Williamtown Contamination Water Working Group Comments on the EIS for the Cabbage Tree Road Sand Quarry Project

Williamtown Water Working Group Comments on the EIS for the Cabbage Tree Road Sand Quarry Project

Source: AECOM Australia Pty Ltd (2015) Sampling Analysis and Quality Plan, RAAF Williamtown Stage 2B Environmental Assessment (Draft), Figure 4

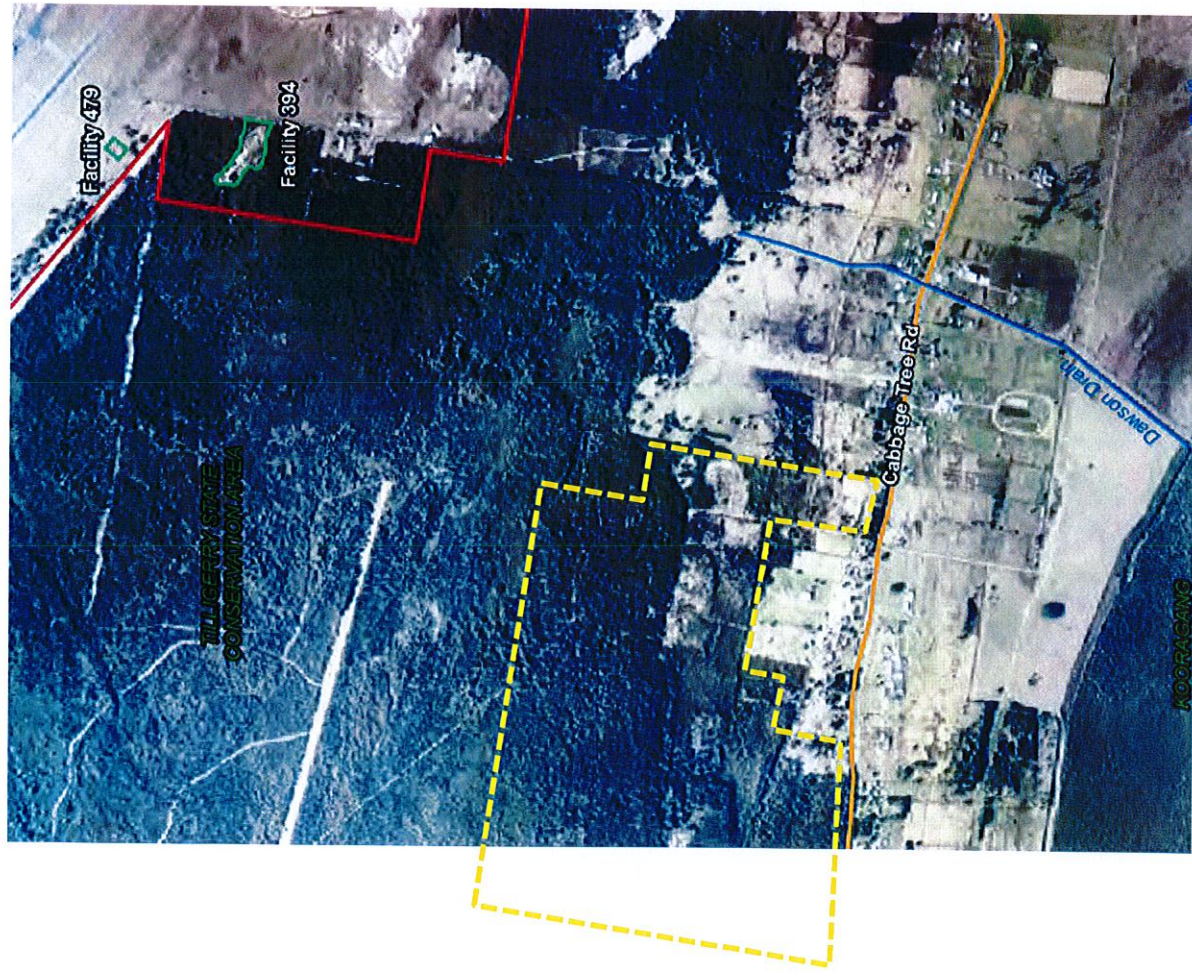
- The EIS indicates that there are no water courses on the site.
- The Sampling, analytical and Quality Plan (SAQP) for the Stage 2B environmental assessment of the Williamtown site (Fig 4, see attached) indicates a tributary of the Dawson Drain extending across a portion of the site, however this may be an ephemeral surface drain.
- PFOS was reported at 0.02 µg/L in Dawson Drain where it intersects Cabbage Tree Rd, which appears to be ~200 metres east of the sand mining site boundary.
- The SAQP included a proposed sampling location (DD8) right at the sand mine site boundary (see attached Figure), but no results have been noted by the WWG to date.

- Based on an inferred southward groundwater flow direction in this area, a plume issuing from the Facility 479 and 374 would likely pass close to, but to the east of, the sand mining boundary
- Nested monitoring wells MW107S/I/D are located approx. midway between the sand mining site and the Facility 479 and 374 source areas – presumably these wells were intended to attempt to define the western boundary of PFAS impacted groundwater. Results from URS (2015) indicate:
 - PFOS was not detected in all three wells
 - PFOA was detected at 0.01 µg/L in the intermediate well (11m depth), and not detected in the others
- Monitoring well MW124 (7.5 m depth) is located on to Cabbage Tree Rd, adjacent to the southern boundary of the sand mining site. Results from URS (2015) indicate:
 - PFOS was detected at 0.01 ug/L
 - No detection for PFOA
